**2012 FORMER COMMUNICATIONS SITE  
ACTION MEMORANDUM**

**FORT WAINWRIGHT, ALASKA  
FINAL  
DECEMBER 2012**

ADEC		DATE: 10/30/2012 REVIEWER: Deb Caillouet PHONE:	ACTION TAKEN ON COMMENT BY: JACOBS ENGINEERING GROUP INC.	
Item No.	Drawing Sheet No., Spec. Para.	COMMENTS	CONTRACTOR RESPONSE	USACE/ADEC RESPONSE ACCEPTANCE (A-AGREE) (D-DISAGREE)

<b>FORMER COMMUNICATION SITE          OVERVIEW OF INVESTIGATION ACTIVITIES          2007 TO 2010          FT. WAINWRIGHT, FAIRBANKS, ALASKA</b>			
	DATE: <b>01 NOV 2012</b>	PROJECT MANAGER: <b>T. HEIKKILIA</b>	FIGURE NO.: <b>A-2</b>

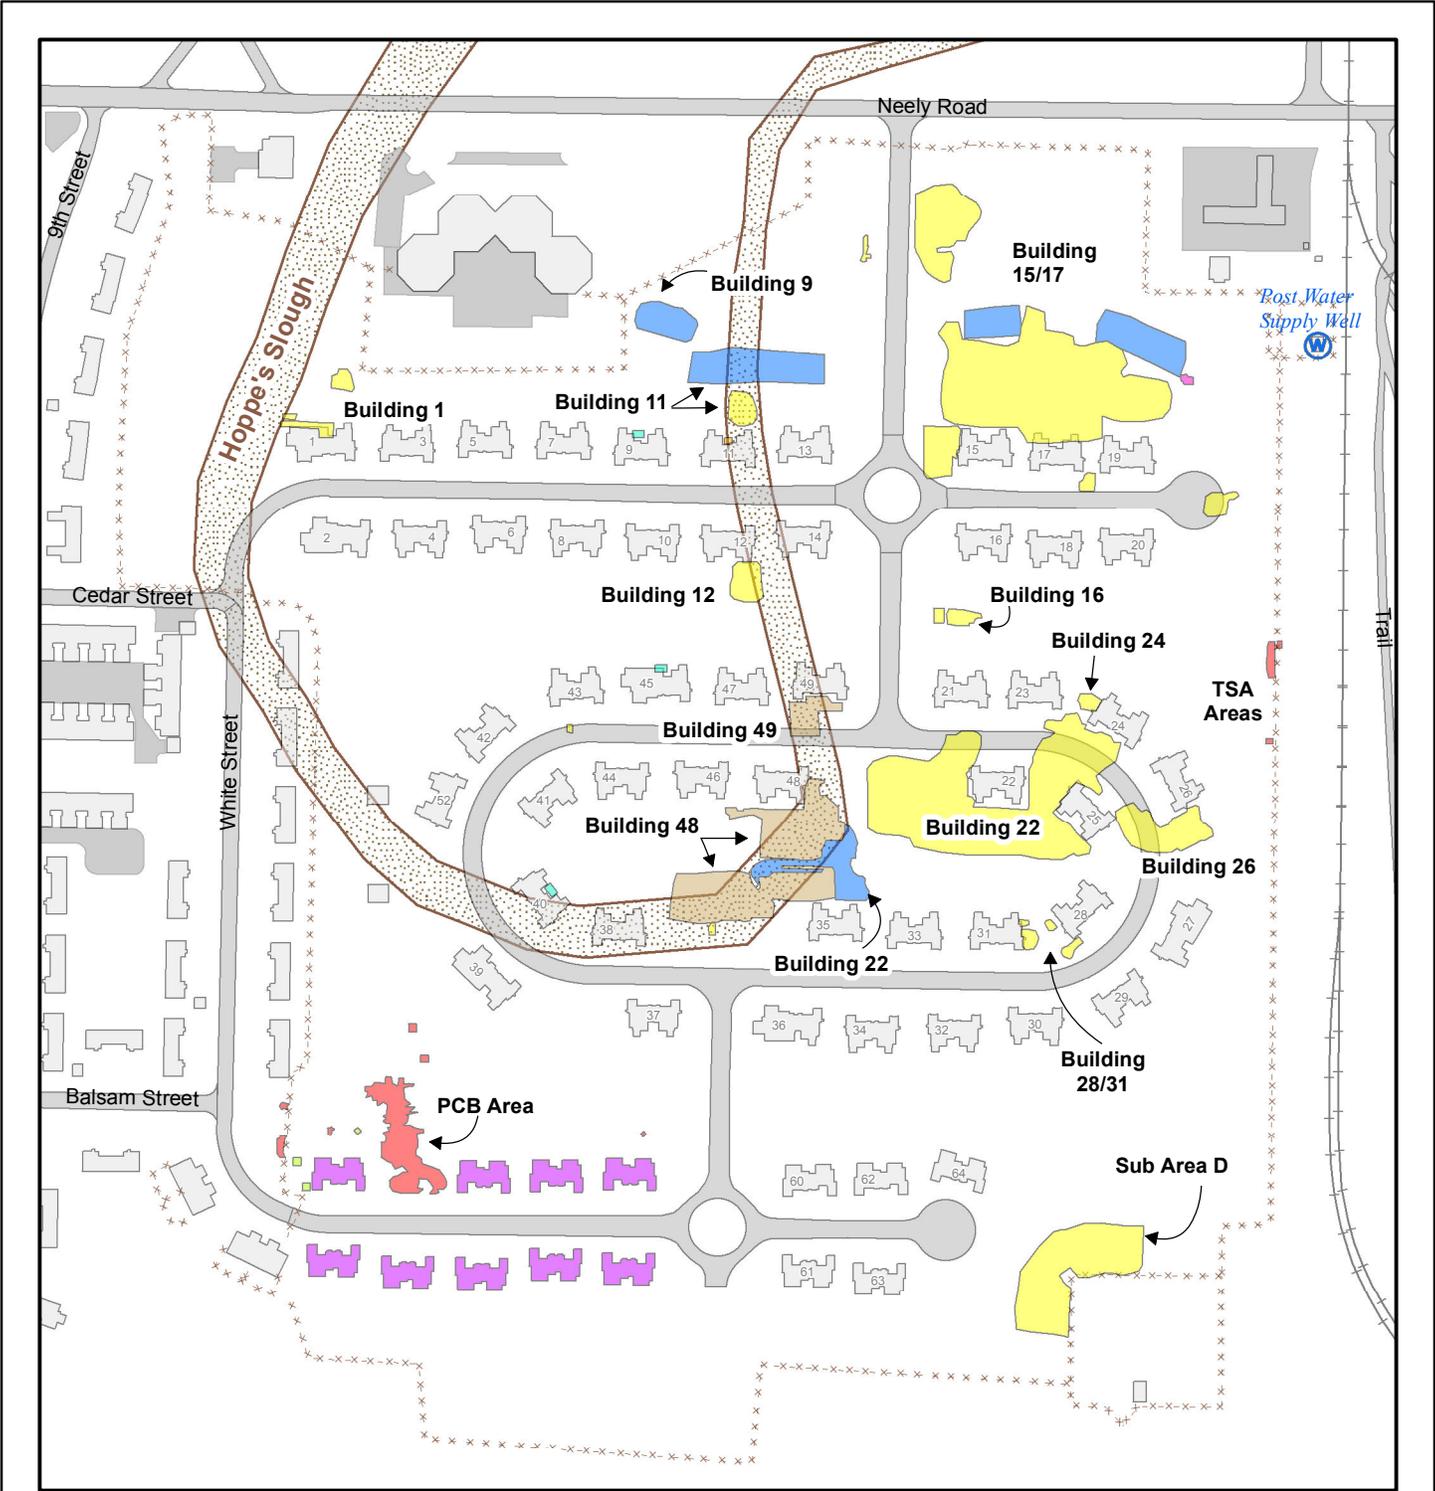
2.	Section 2.1 Page 2-2	On page 2-2 of Section 2.1 (and other sections) references are provided to Attachment A, Figure XX. There is no Attachment A included with this document and no figures matching the description are included. Please revise.	Accepted. All references to “Attachment A” will be updated to say Appendix A.  Accepted. Figure A-2 will be updated to include the outline of the former slough.

<b>FORMER COMMUNICATIONS SITE 2011 AREAS OF INVESTIGATION</b>		
FORT WAINWRIGHT, FAIRBANKS, ALASKA		
<b>JACOBS</b>	DATE: 01 NOV 2012	PROJECT MANAGER: T. HEIKKILA
		FIGURE NO: A-3

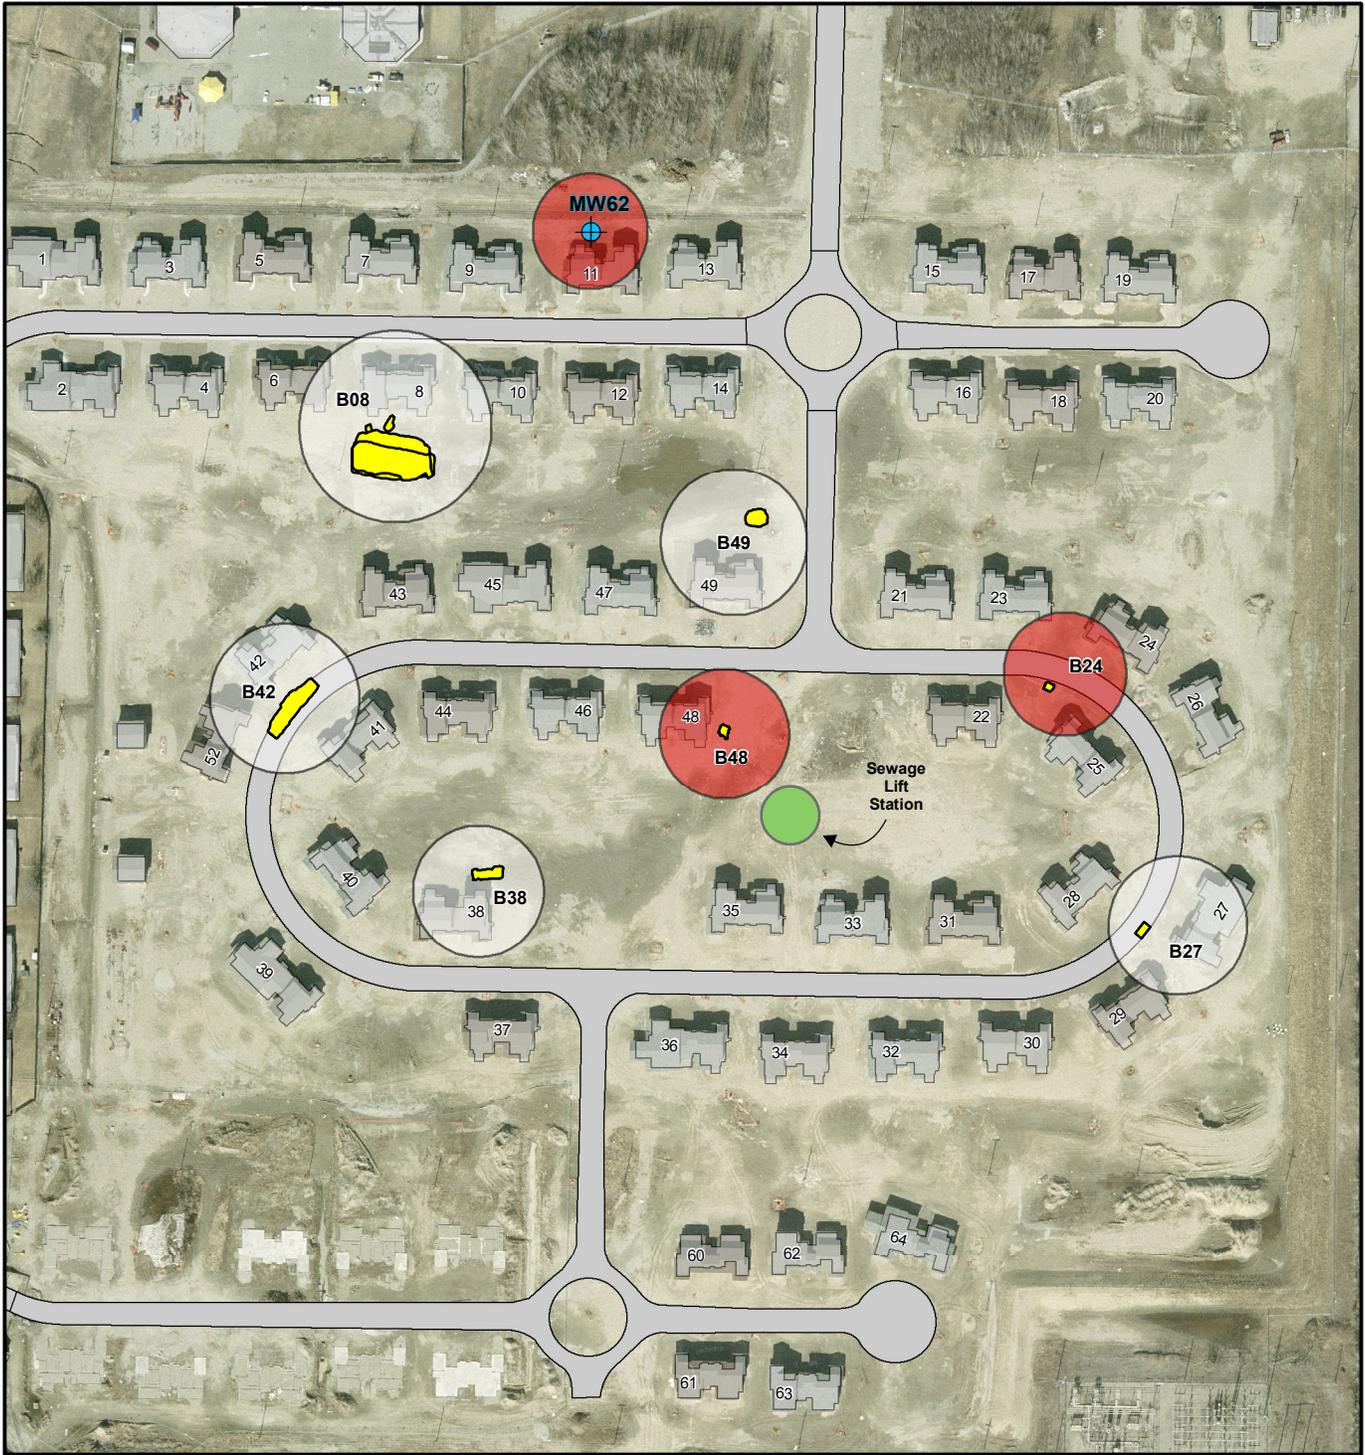
4.	Figure A-3	Figure A-3. There are three locations identified as “planned” that have already occurred and there is some action that has not been included in the text indicated at MW14. Please review and revise as needed.	Accepted. The “planned” label refers to the areas that were known about and planned for prior to the field season as opposed to the areas that came up only when the construction contractor encountered them. These areas will be changed to reference the “Soil Removal Locations” and “Construction Support Locations” respectively.  MW14 was a monitoring well that was converted to flush mount prior to paving activities. Since it does not affect the remediation at the site, it will be removed from the figure.
